FORM APPROVED  
OMB NO. 1004-0137  
Expires: January 31, 2018**SUNDRY NOTICES AND REPORTS ON WELLS**  
*Do not use this form for proposals to drill or to re-enter an abandoned well. Use form 3160-3 (APD) for such proposals.*5. Lease Serial No.  
NMNM83037

JONES CANYON 4 FED 4

OXY USA WTP LP - Proposed  
Jones Canyon 4 Federal #4  
API No. 30-015-30487

**Permanent Abandonment of Federal Wells  
Conditions of Approval**

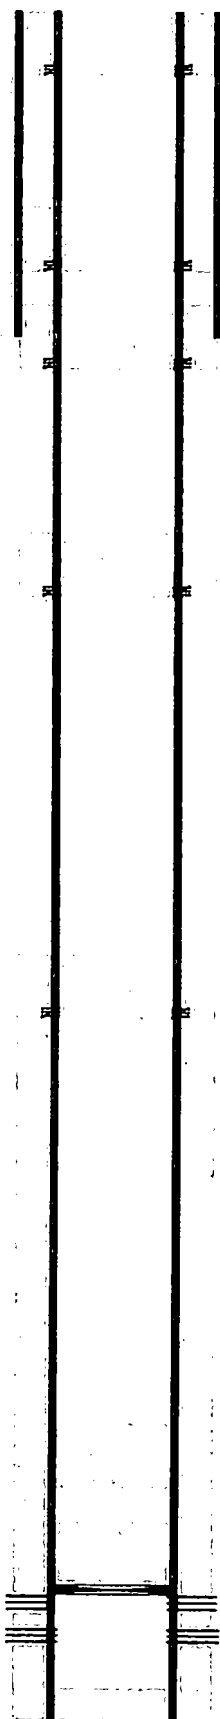
95sx @ 250'-Surface ✓

45sx @ 1250-1130' WOC-Tag ✓

45sx @ 1650-1530' WOC-Tag ✓

50sx @ 2680-2550' WOC-Tag ✓

55sx @ 4957-4807' WOC-Tag ✓

40sx @ 7333-7158' WOC-Tag ✓

CIBP @ 7774' w/ 40sx to 7594' ✓

SA 1204

GI. 2630

BS 4907

WC 7283

C.scd 7817
